From: Pederson Ronda M (AREVA NP INC) [Ronda.Pederson@areva.com]
Sent: Friday, June 05, 2009 10:38 AM
To: Getachew Tesfaye
Cc: BENNETT Kathy A (OFR) (AREVA NP INC); DELANO Karen V (AREVA NP INC); WELLS Russell D (AREVA NP INC)
Subject: Response to U.S. EPR Design Certification Application RAI No. 199, FSAR Ch. 5, Supplement 1
Attachments: RAI 199 Supplement 1 Response US EPR DC.pdf

**Request for Additional Information No. 199 (749, 2243, 2309), Supplement 1,
Revision 0**

U. S. EPR Standard Design Certification

**QUESTIONS for Component Integrity, Performance, and Testing Branch 1
(AP1000/EPR Projects) (CIB1)**

Figure 05.02.03-17-1—Time-Temperature Sensitization Diagram for Titanium Stabilized (Type 321) and Niobium Stabilized (Type 347) Stainless Steel

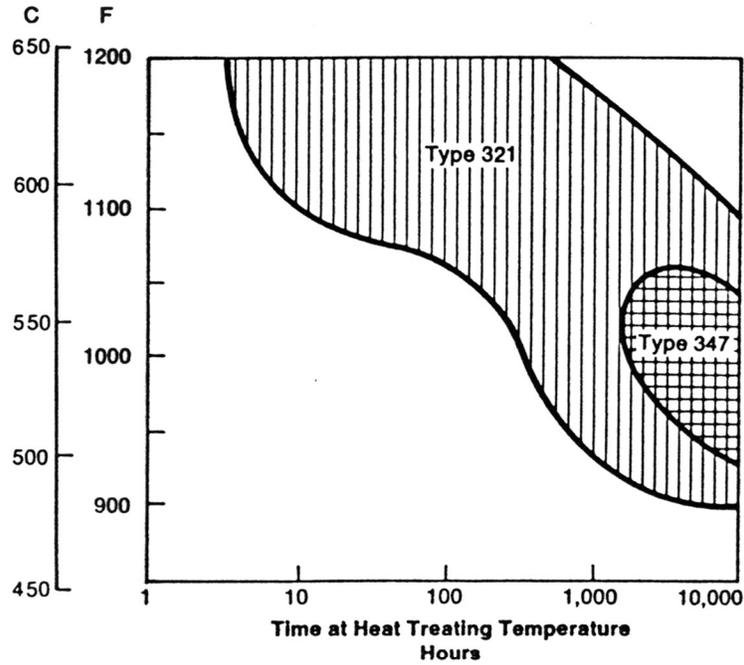
1. Identify the stabilizing heat treatment temperature, for stabilized grades of stainless steels, and a basis for its selection including a discussion on verification testing that has been or will be performed to determine that the stabilizing heat treatment is adequate for material in the RCS environment to prevent stress corrosion cracking.

The modified chemical composition verifies that the amount of free carbon is lower than the free carbon levels found in “low carbon” (maximum 0.03 percent) grades of non-stabilized austenitic stainless steels. Typical bulk carbon content of Grade 347 ranges from 0.02 percent to 0.03 percent. Therefore, grain boundary precipitation of chromium carbides is virtually suppressed. The behavior of Grade 347 stainless steel with respect to intergranular attack and SCC is described in Reference 1 and Reference 2. Figure 05.02.03-17-1—Time-Temperature Sensitization Diagram for Titanium Stabilized (Type 321) and Niobium Stabilized (Type 347) Stainless Steel (Reference 3) displays the time-at-temperature regimes necessary to cause any thermal sensitization for a regular Grade 347.

As required by the material specification, Grade 347 is corrosion tested according to ASTM A 262 Practice E after being subject to sensitizing heat treatment. For Grade 347 components not subject to PWHT, the sensitizing heat treatment prior to A 262 Practice E is 1202°F for 30 minutes, which is a time-at-temperature regime suitable for detecting any improper solution annealing in Grade 347. For Grade 347 which will be subject to PWHT during fabrication, the A 262 Practice E test is performed after a sensitizing heat treatment for 12 hours at 1076°F, acting as a conservative, simulated PWHT. In any ASTM A 262 tests, intergranular attack is not permitted regardless of depth.
